<b>Subject:</b>  CHECK ENGINE LIGHT ON WITH DTC P013A:00	<b>Bulletin No:</b> 01-009/15
	<b>Last Issued:</b> 05/26/2015

2013-2016 CX-5

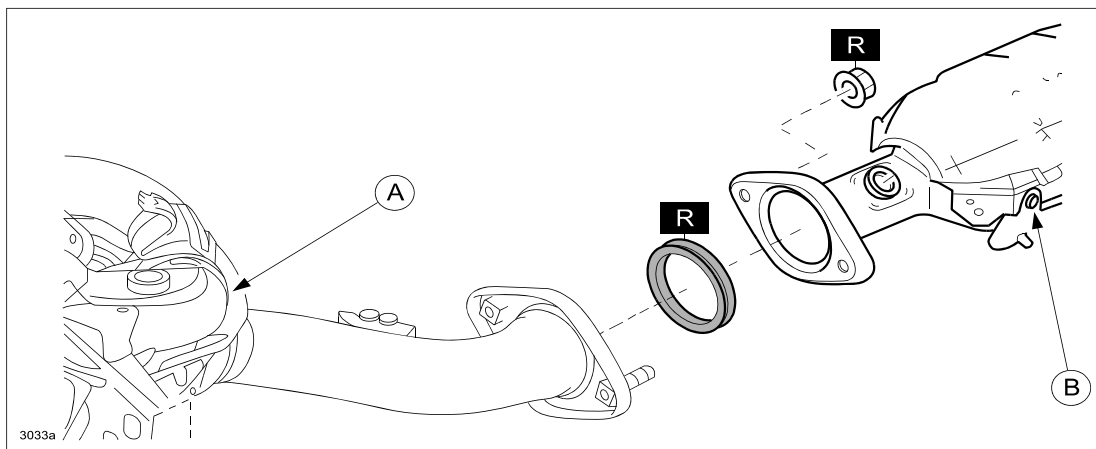
This concern may be caused by an impact from a speed-bump or other source, causing a deformation of the gasket between the exhaust manifold (WU-TWC) (A) and the TWC (B).

1. Verify the customer concern.
2. Inspect the exhaust system for a gas leak from the gasket.
3. If a leak is detected from gasket, replace it with a modified part according to the instructions on MS3 online or the Workshop Manual (section 01-15 EXHAUST SYSTEM REMOVAL/INSTALLATION [SKYACTIV-G 2.0, SKYACTIV-G 2.5]).

- Replace both flange nuts with new ones.
- Make sure to tighten the flange nuts to the specified torque spec.

**Tightening Torque: 37.6 ft. lbf. {51 N-m}**
